UNITED STATES PATENT AND TRADEMARK OFFICE

10/044,368

Office Action Summary	Application No. 10/044,368	Applicant(s) BROOME ET AL.	
	Examiner Darwin P. Erez	Art Unit 3773

DETAILED ACTION

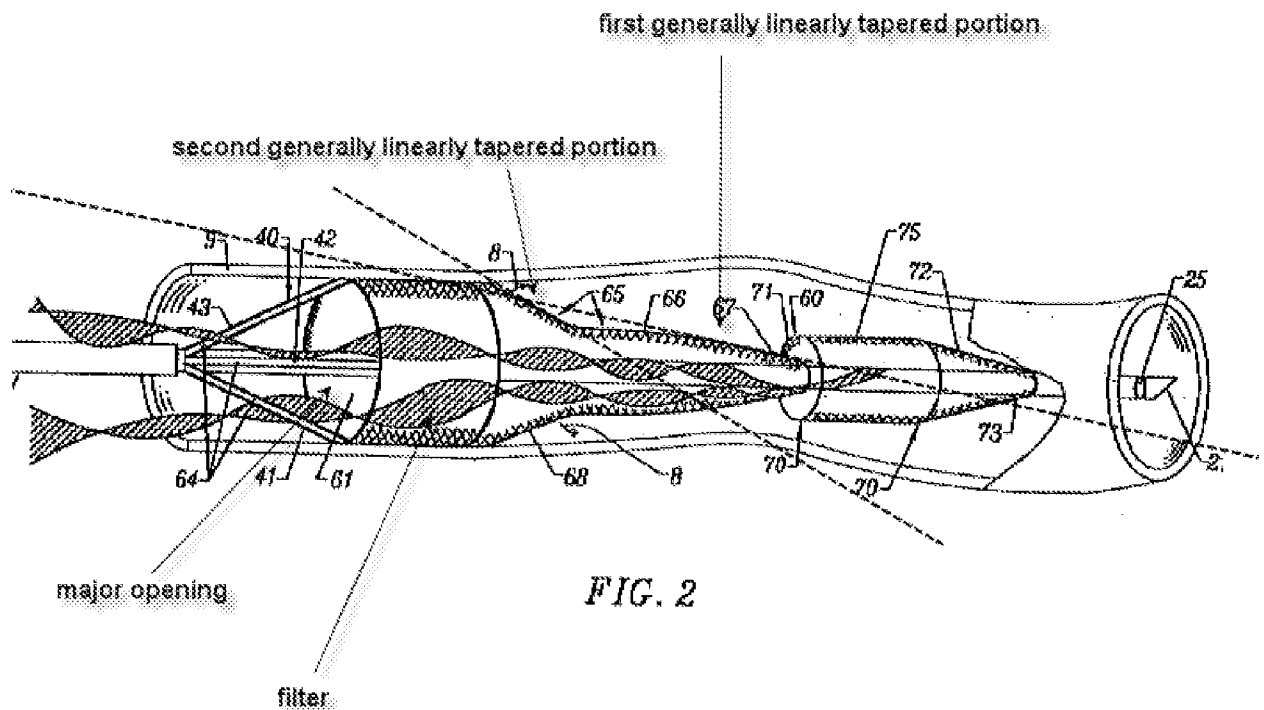
(claims 52, 58-63, 70-72, 78-83, 92 and 93) Stanford discloses a filter assembly comprising an elongate shaft **20**, a filter disposed and attached to a distal end of the shaft (see attached Fig. 2 below, or even in Fig. 15), the filter including a filtering region (the open portion) and an attachment region; wherein the filtering region includes a major opening defined adjacent the proximal end (see figure below) and is comprised of only a single layer of filter membrane that defines a filter basket and extending between the major opening and the distal end of the filtering region, the filtering region comprising apertures to allow the passage of blood through the filtering region; the filter membrane further comprising a first "generally linearly" tapered portion defining a first angle that is lesser (or different) than a second angle defined by a second "generally linearly" tapered portion (see figure below); wherein the filter has an expanded (Fig. 2) and contracted shape (Fig. 3); wherein the first tapered portion extends at the first included angle for a "substantial length" of the first tapered portion and the second tapered portion extends at the second included angle for a "substantial length" of the second tapered portion.

Stanford also discloses the filter including an expandable frame comprising Nitinol (col. 4, ll. 26); wherein the expandable frame includes a plurality of struts or ribs **41,42,43** that are adapted to bias the filter in an expanded position, wherein the free ends (proximal ends) of the ribs are attached to the opened mouth frame of the filter.

Stanford is silent with regards to the expandable frame disposed within and supporting the first tapered portion and the second tapered portion.

(claim 90) The second tapered portion extends proximally from the proximal end of the first tapered portion (see figure above).
